**AMENDMENT OF SOLICITATION/MODIFICATION OF CONTRACT**

14. DESCRIPTION OF AMENDMENT/MODIFICATION (Organized by UCF section headings, including solicitation/contract subject matter where feasible.)

**BUILDING 446 HVAC REPLACEMENT**  
 PARTIAL SECOND FLOOR DEMOLITION PLAN

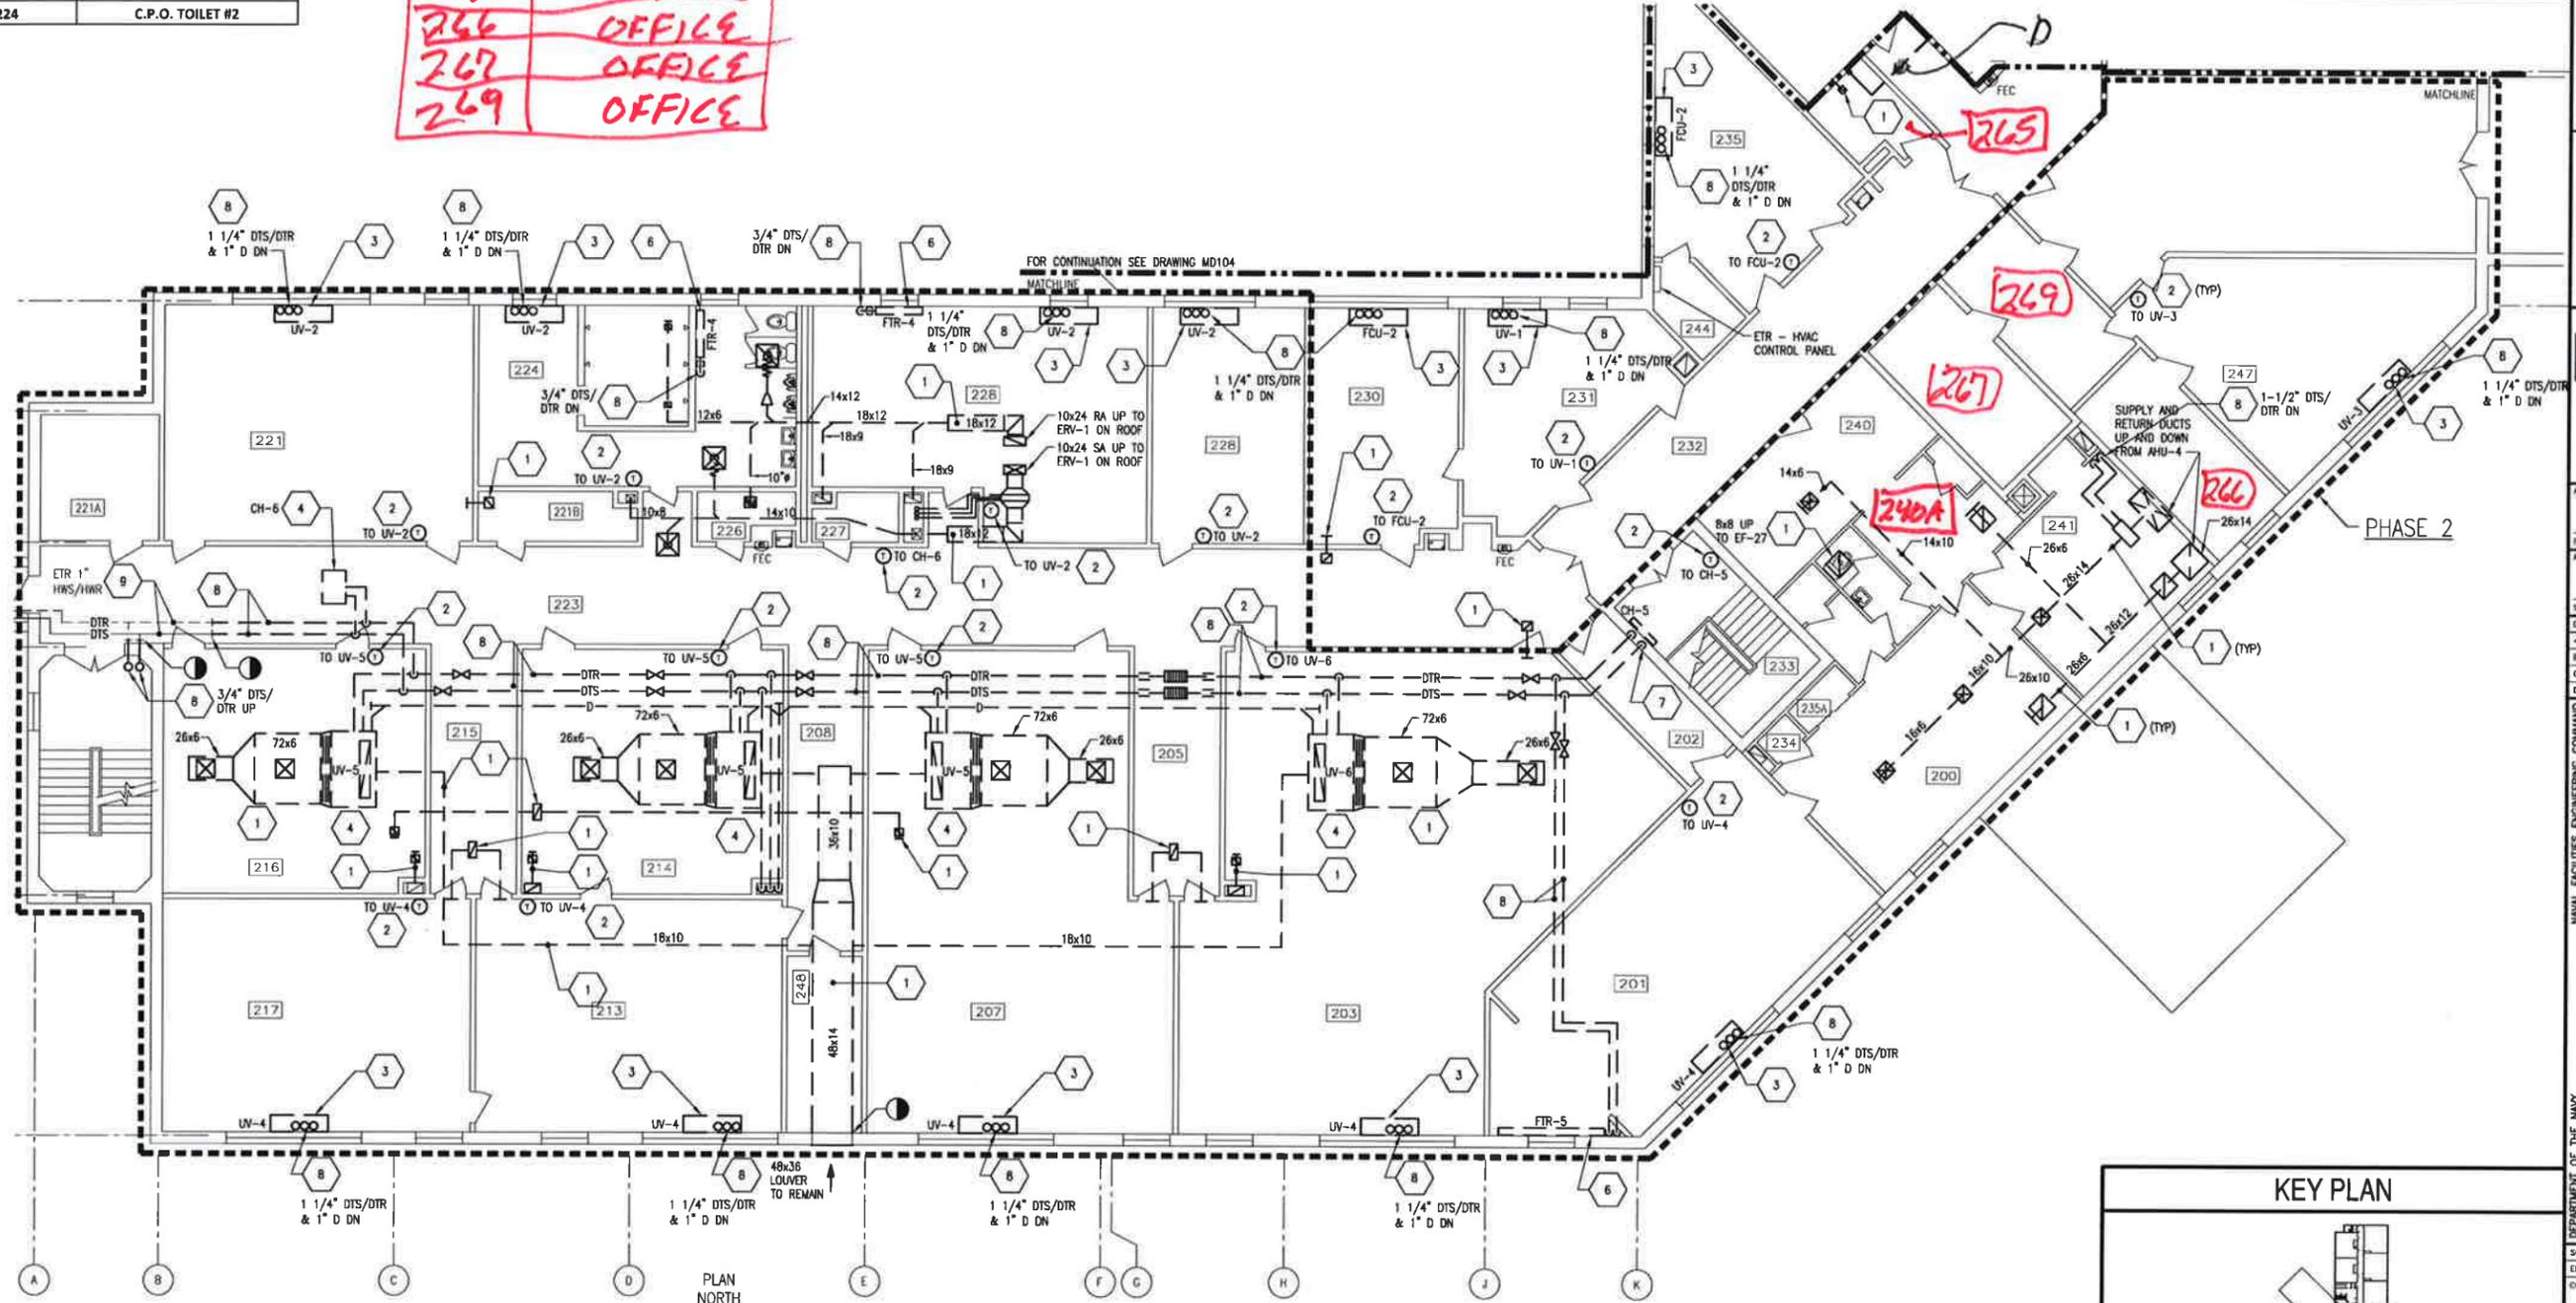
**8). MD-103 shows two rooms adjacent to room #235 without number designation. Please advise if any work exists here, what room number are and what phase it is associated with?**

**9). Same as question number 8, MD-103 there are three rooms adjacent to rooms 240 and 247 with no number designation.**

Response: We could only locate one room adjacent to 235 without a number designation. This room is a janitor's closet and demo work is indicated. Please see attached sketch for new work required in this room. This room is included in Phase 1.

Response: Work is required as indicated in and around these rooms as shown. The two adjacent to 247 are Offices. The one adjacent to 240 is a Coffee Mess. Please see attached sketch. Work occurs in Phase 2.

SCALE: AS NOTED  
 PROJECT NO.: 1312379  
 CONSTR CONTR NO.  
 NAVFAC DRAWING NO.: 12684357  
 SHEET 16 OF 47  
**MD104**  
 SHAWFORM REVISION: 10 MARCH 2009  
 NAVSTA DWG. NO. 42250-390

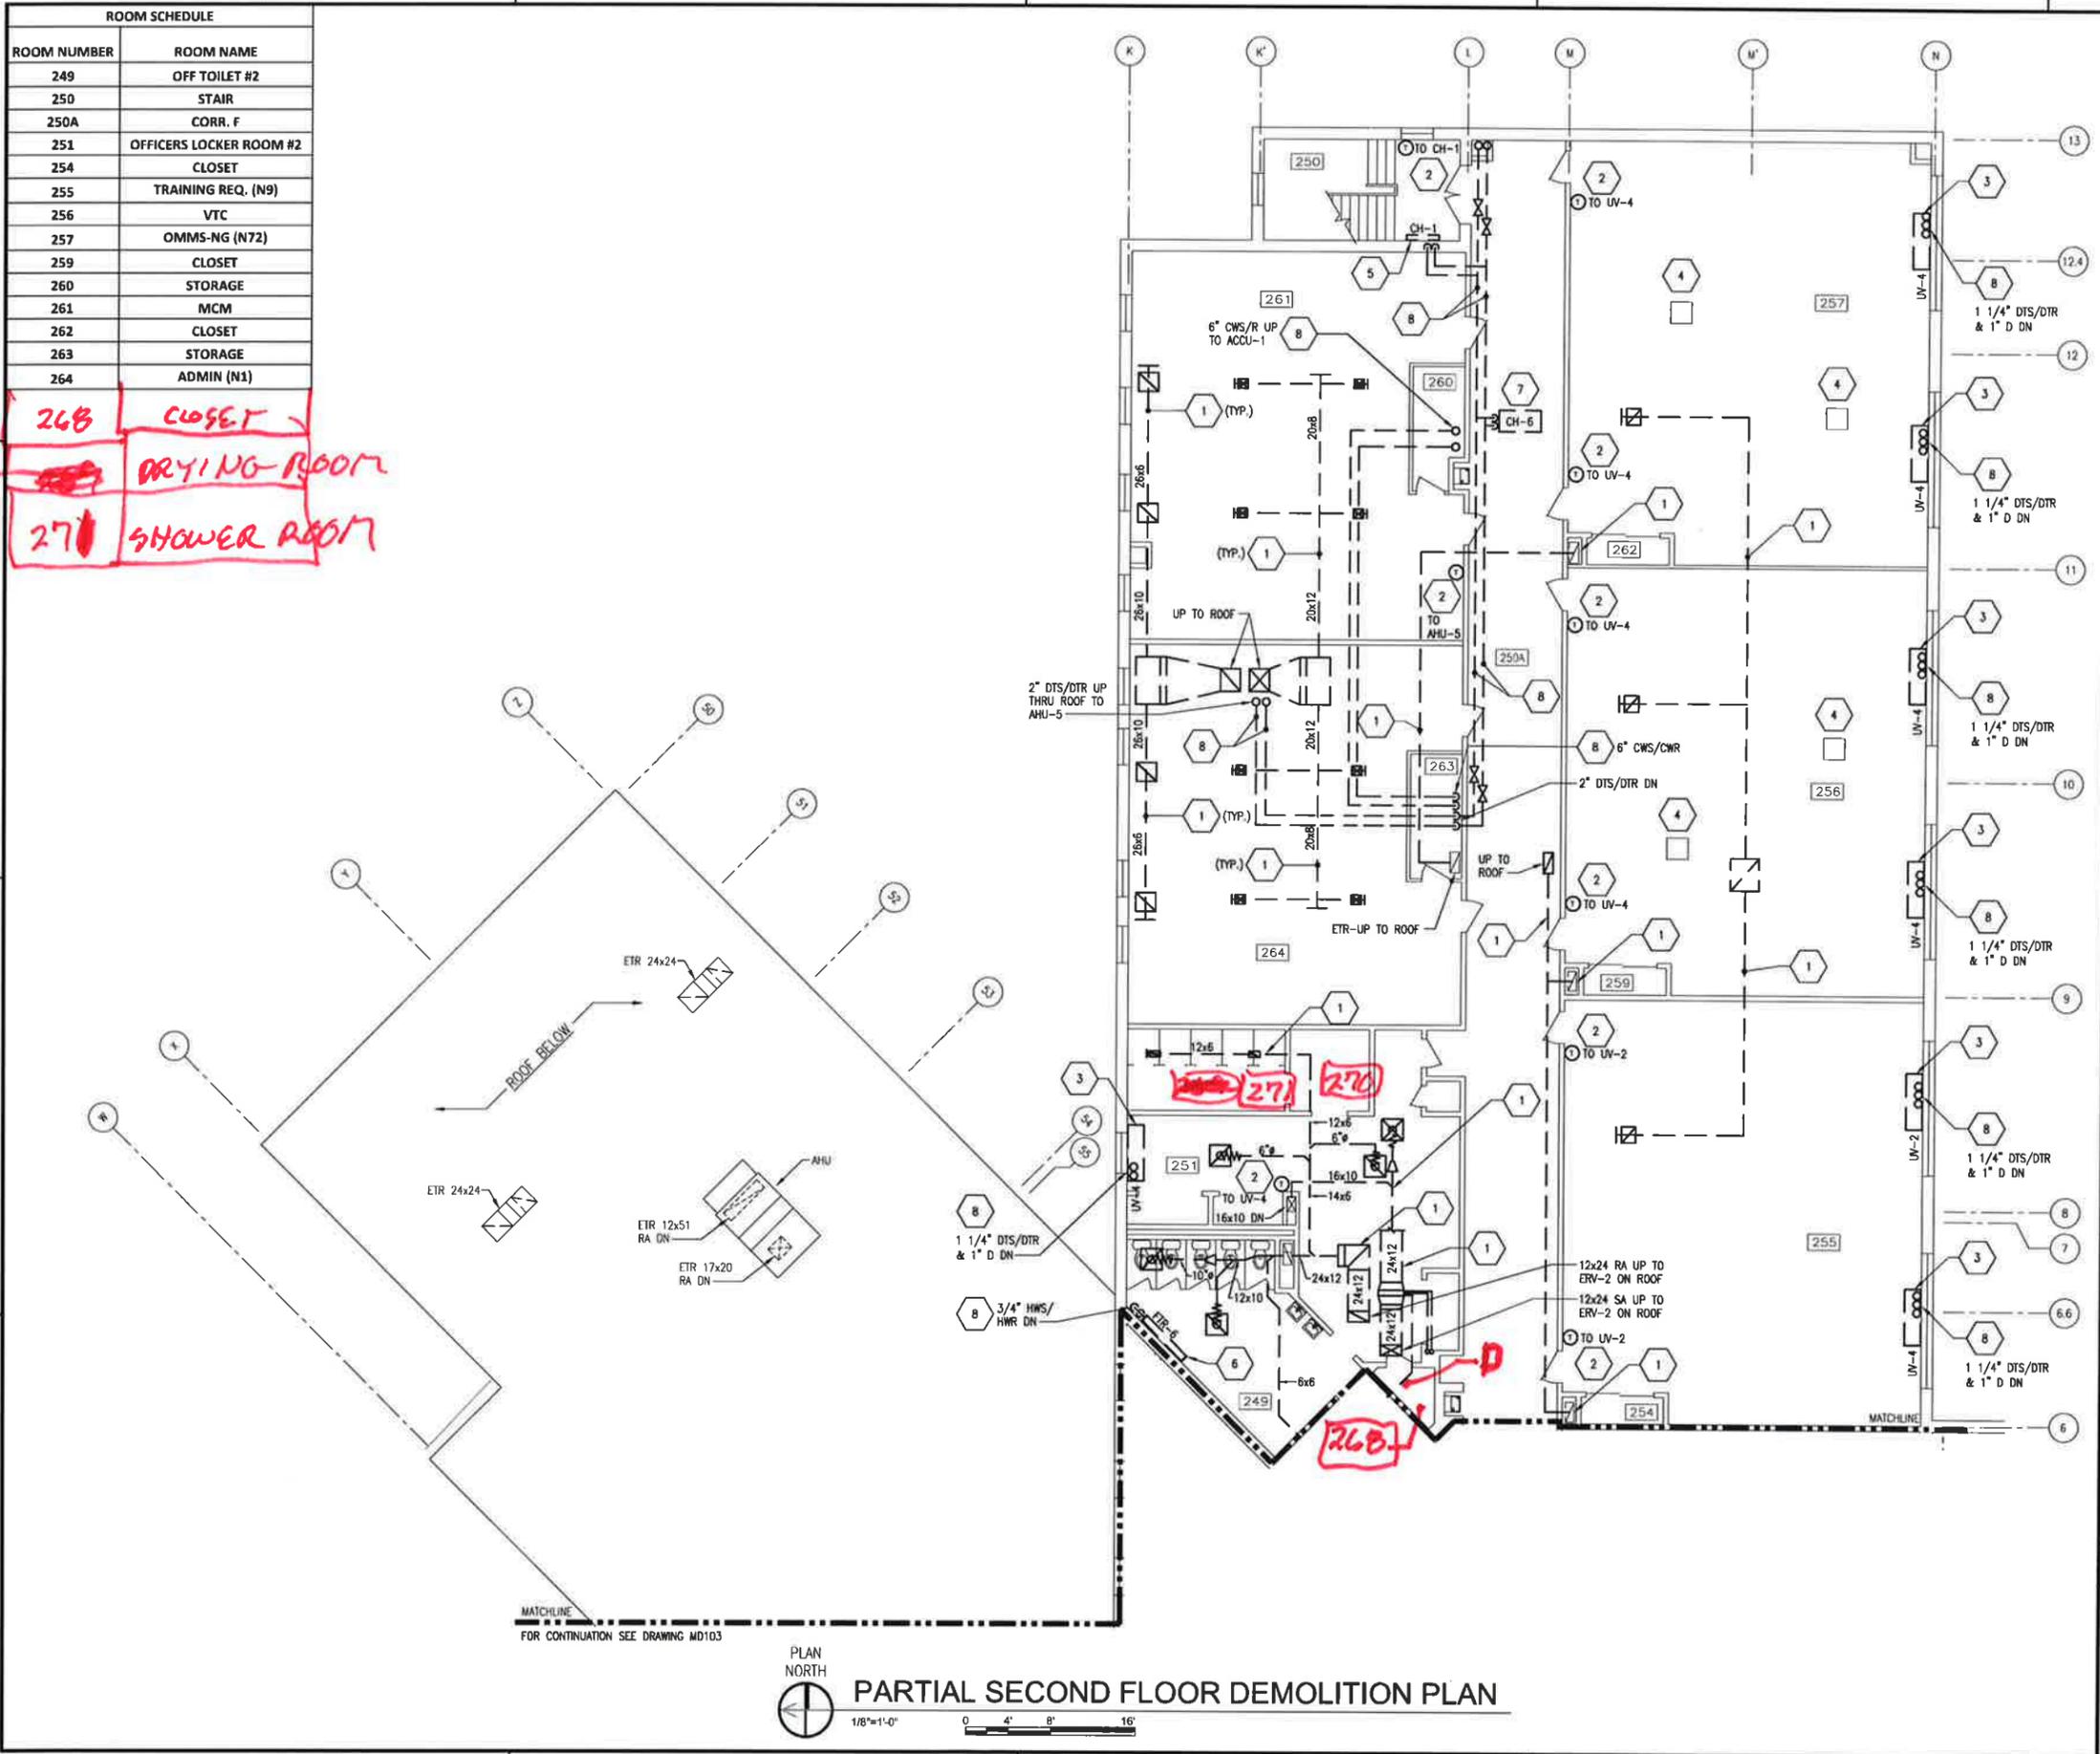
**10). Same as question number 8, MD- 104 there is room with door inside restroom #249 with no designation.**

**11). Same as question number 8, MD-104 there is a room restroom with no designation so is this room attached to room 251 or 249 or will have its own designation?**

Response: Work is as indicated in and around this room as shown. This is a closet. Please see attached sketch. Work occurs in Phase 1.

Response: Work is as indicated in and around these rooms as shown. These rooms are an extension of 251 Officer's Locker Room #2. Work occurs in Phase 1.
